Incorrect Center Bearing Mounting Hardware

Section: Function Group 453

Year	Model
2026	AN, PI, GR

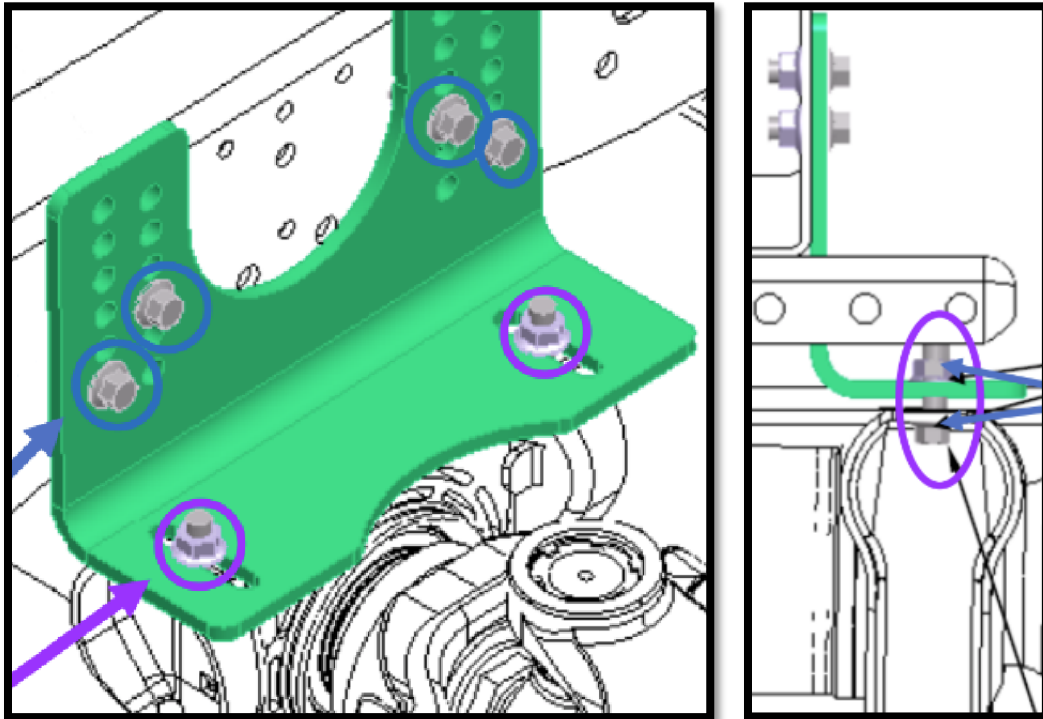
5. Locate the center bearing bracket.

6. Remove and install one fastener at a time for the bracket and discard all removed hardware. Install top and bottom washers for the bottom bracket connections.

7. Torque nuts to specification.

Tightening Specification
106 N-m (78 Ft-lbs)
